*RE: Green America Recycling, LLC/Continental Cement Company, LLC
Facility ID#: MOD054018288
MO ID#: 002430
Class 2 Permit Modification Request*

Green America Recycling, LLC (GAR) and Continental Cement Company, LLC (CCC), located in Hannibal, Missouri, are requesting a modification to the facility's RCRA Hazardous Waste Management Permit (MOD054018288). GAR intends to make the following changes to the operations at the facility that deal with hazardous waste management:

NOTICE OF PERMIT MODIFICATION

GENERAL ARRANGEMENT
GREEN AMERICA RECYCLING
 NEW DIRECT BURN SYSTEMS
 10107 HWY 79
 HANNIBAL, MO 63401

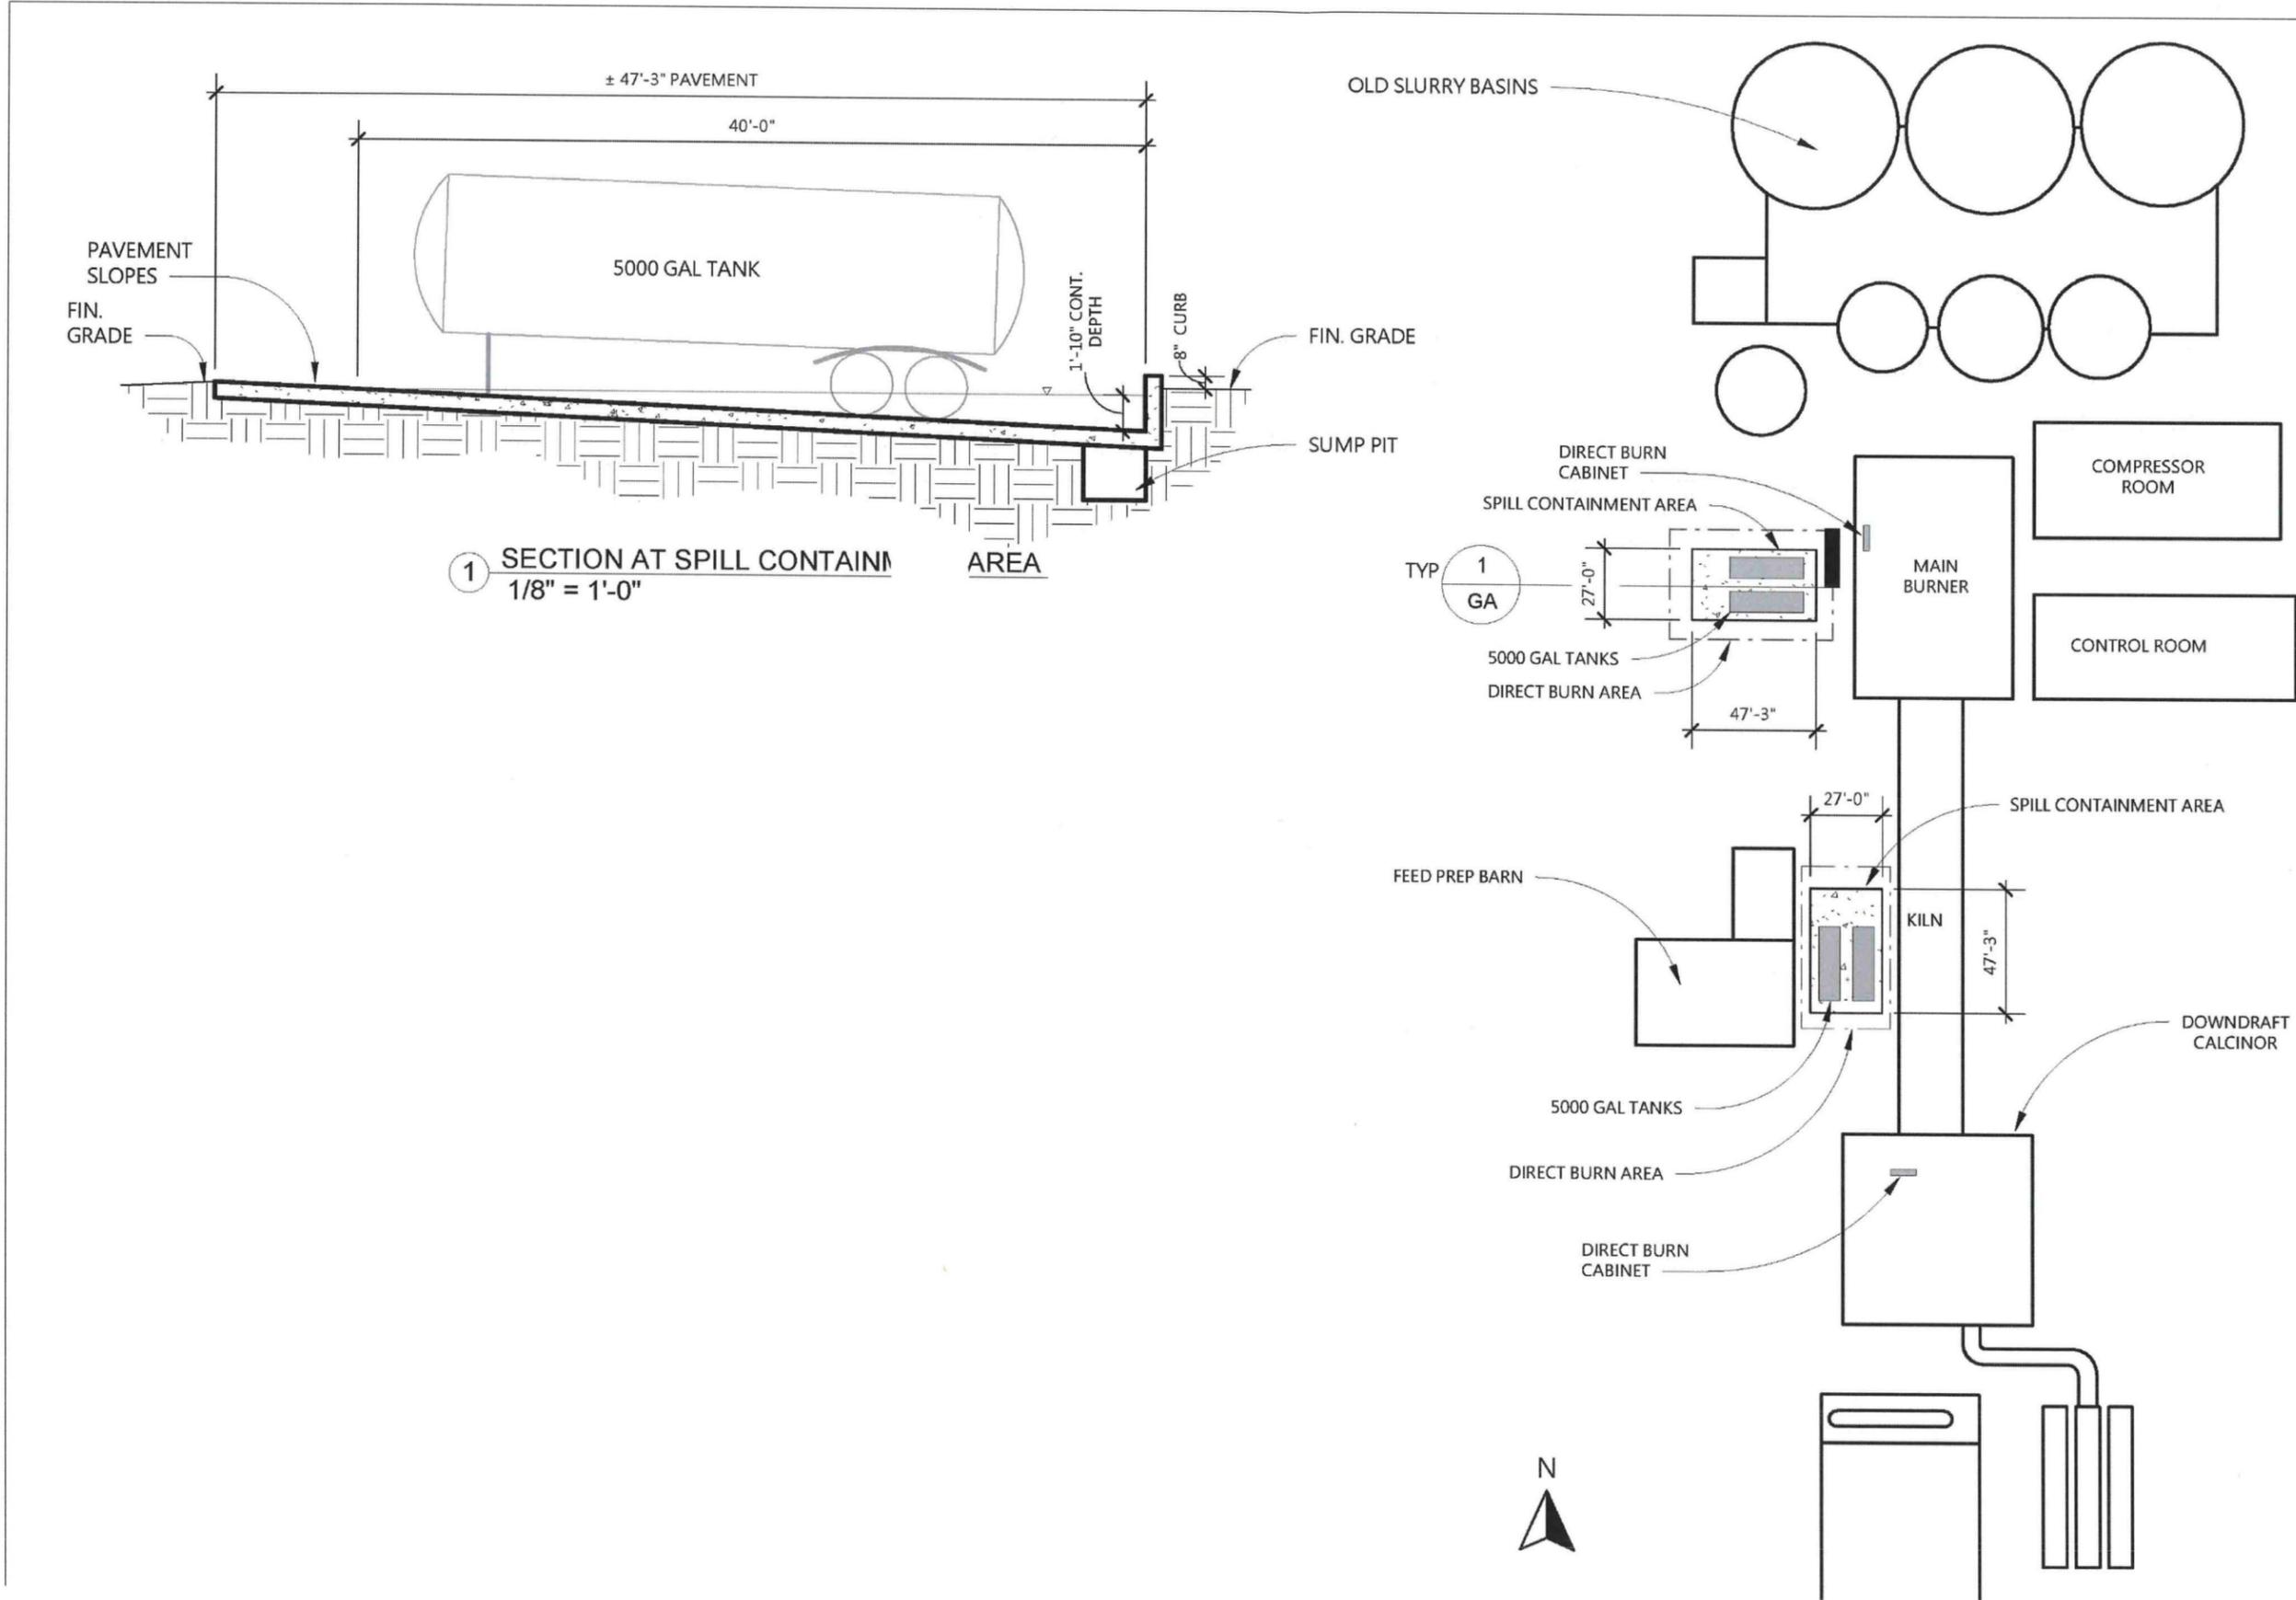
GAR is proposing to install two unloading pads along the west side of the rotary kiln in order to facilitate feeding wastes to the pre-calciner and the rotary kiln without the need to offload the trucks into the tank system and feeding the fuel from there. See Drawing GA, General Arrangement for a plan and section view of the proposed units.

Each unloading pad will provide adequate secondary containment for two (2) 6,000-gallon tankers (four total) based on the largest container volume. A rainfall allowance is included since the pads are not under roof.

See Table 2 for the secondary containment calculations including allowance for 5.29 inches of precipitation from a 24-hour, 25-year frequency rain event.

DRUM AUGER RENDERINGS
EQUIPMENT PRO
 DRUM AUGER
 SCHEMATIC DESIGN

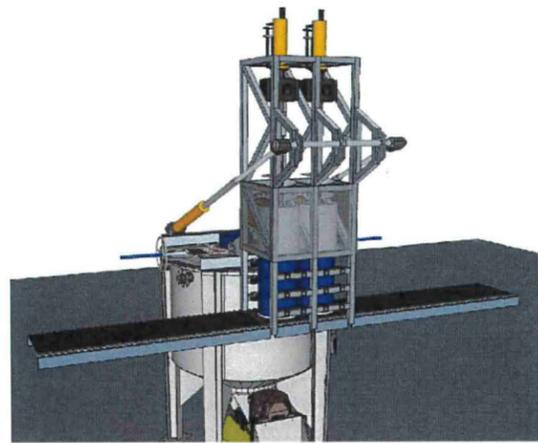
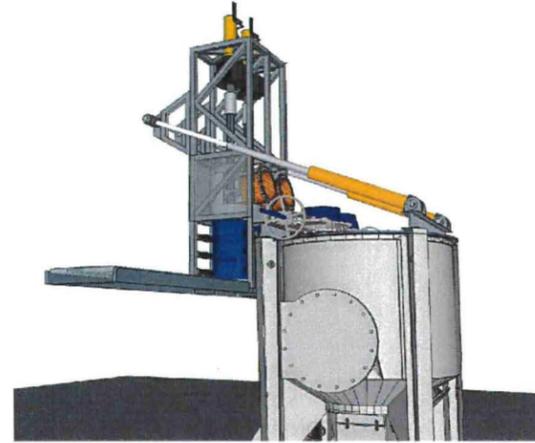
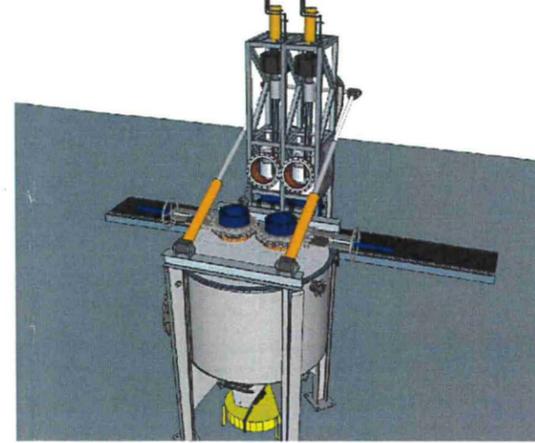
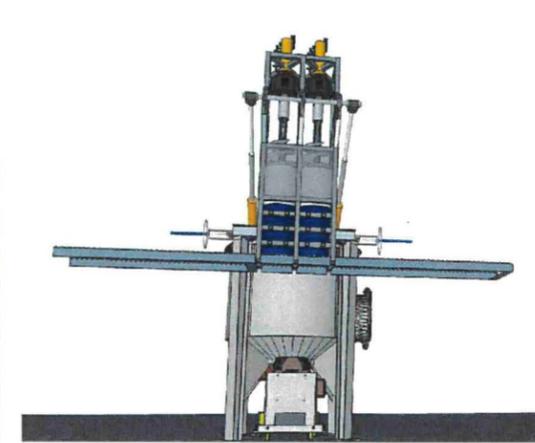
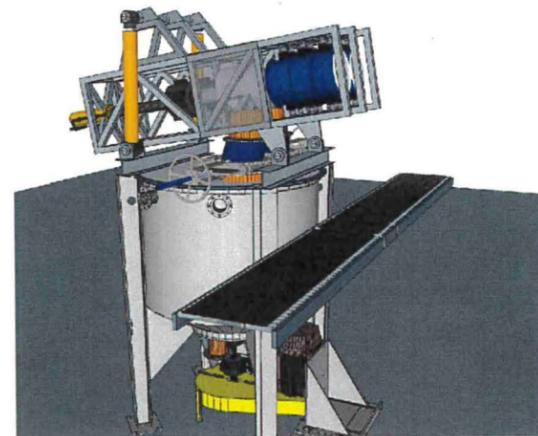
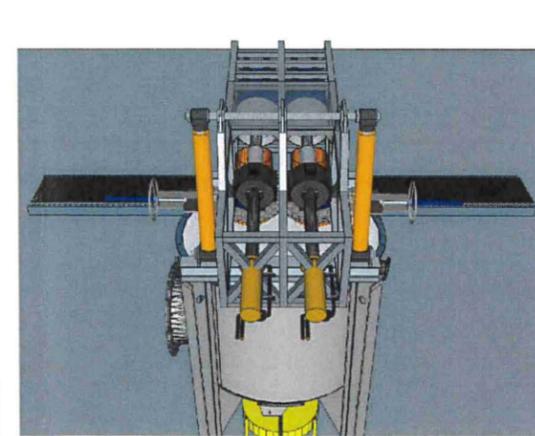
A new drum augering system will be installed in Feed Prep #2, replacing the existing system. The new system will be built next to the existing system, allowing for continued drum processing during construction, but the existing system will be removed from service prior to startup of the new system. The new system consists of a similarly sized hydropulper tank with a drum tipping system that is capable of processing two drums at a time. The new system will be permitted for 587 short tons per day treatment. Images of the new hydropulper and drum tipper system are included in Drawing S1, Drum Augering Rendering.

**WASTE PROCESSING UPGRADES
 CONTAINER STORAGE AREA 4
 GENERAL ARRANGEMENT
 PLAN VIEW OF STORAGE LAYOUT**

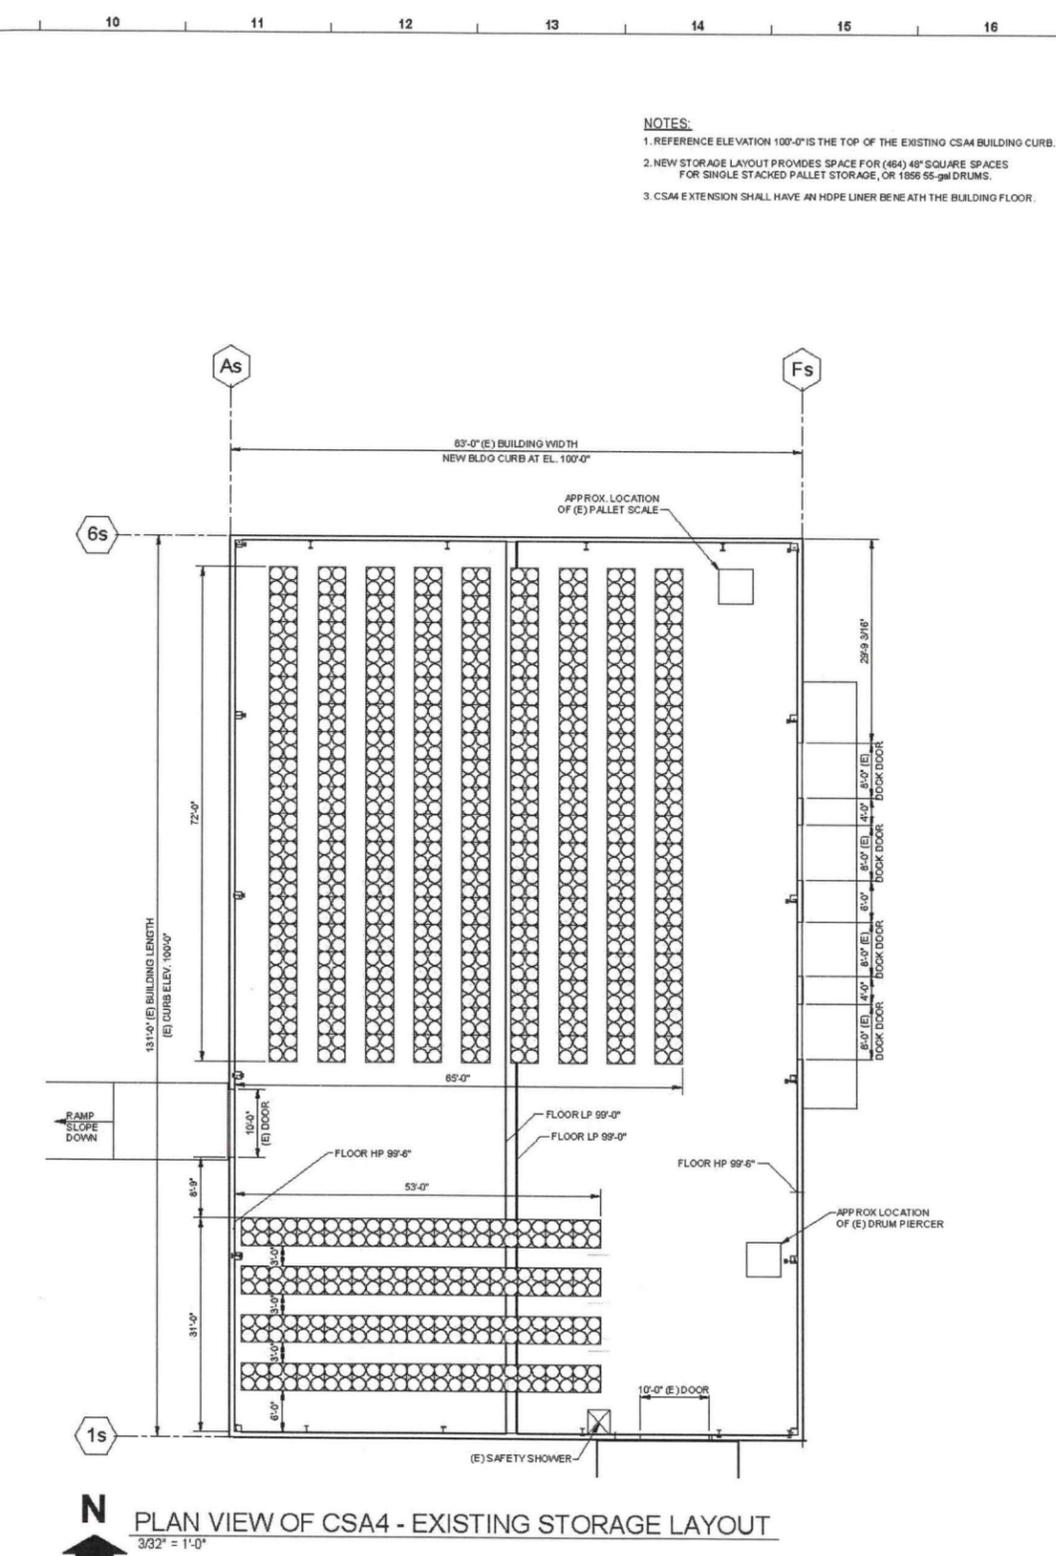
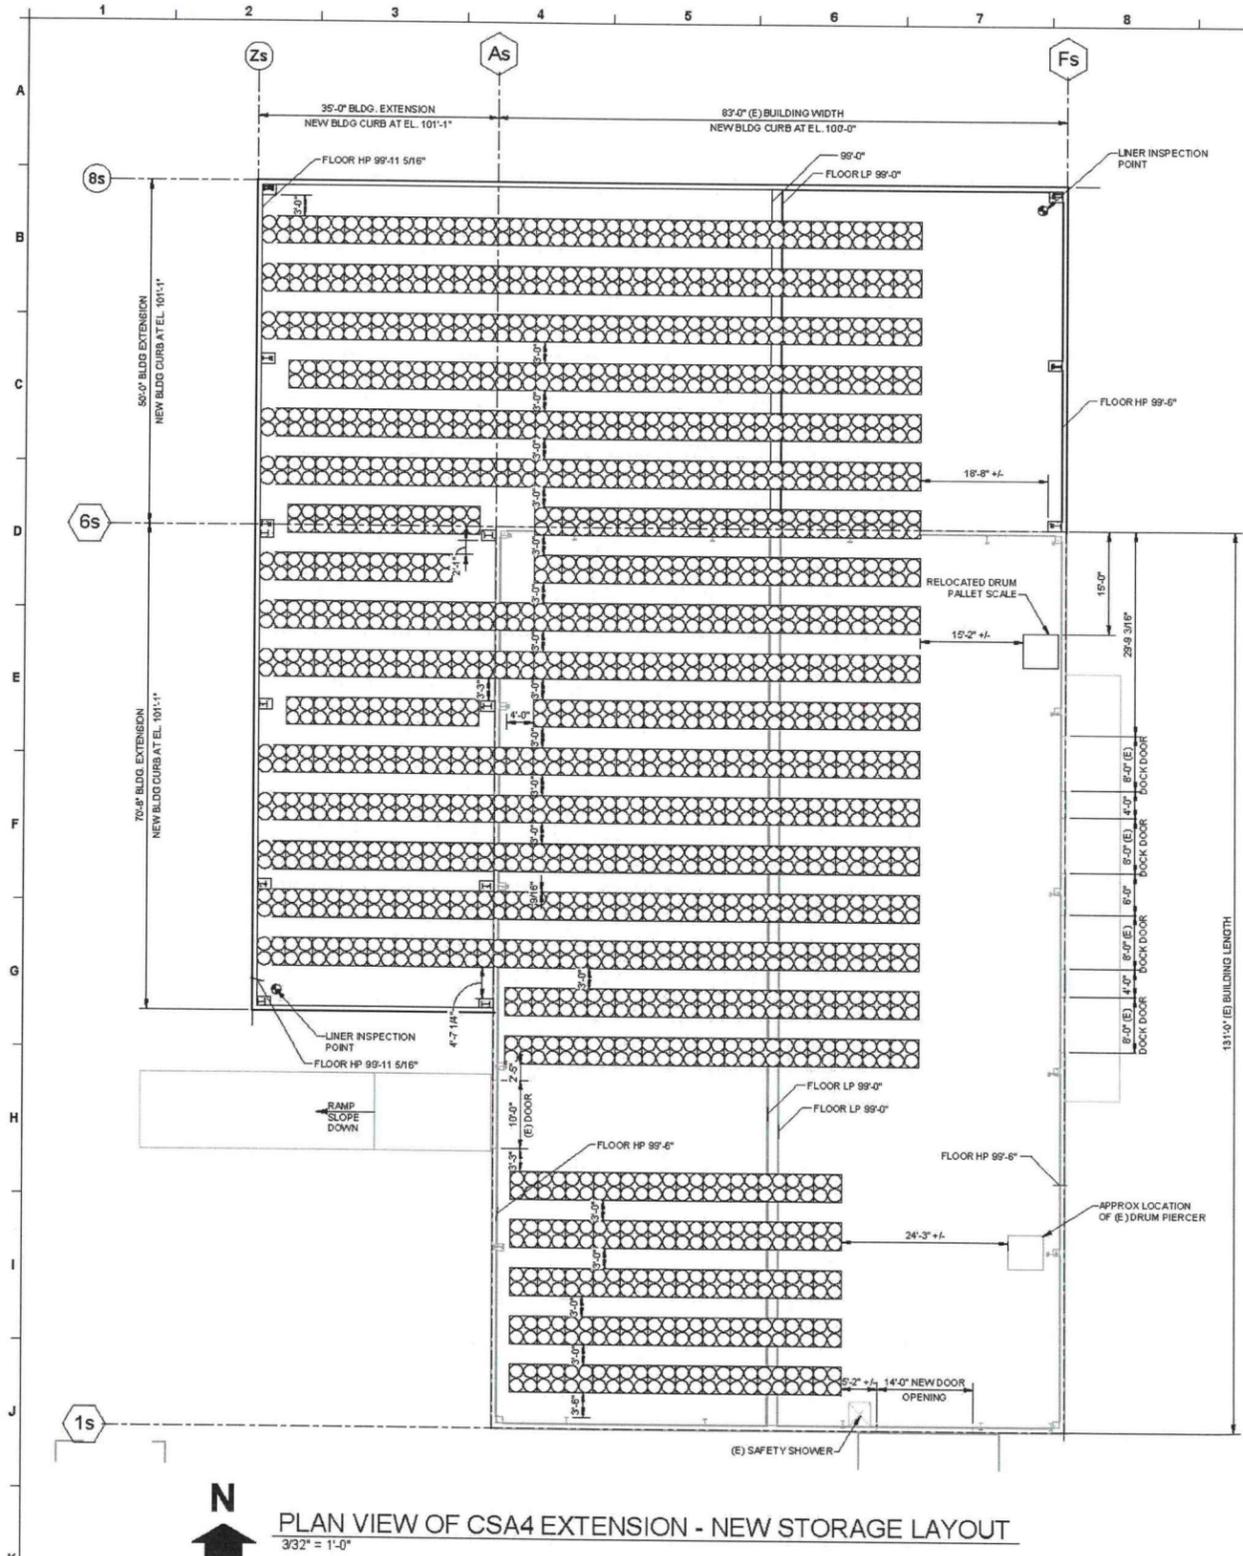
The existing CSA #4 will be enlarged by adding an L-shaped expansion around the northwest corner of the building, all within the expanded CSA #4 building. See attached Drawings 1382-GA-115 and 1382-SC-101 for dimensions and containment details. The proposed pallet layout within the room is shown in attached Drawing 1382-GA-116.
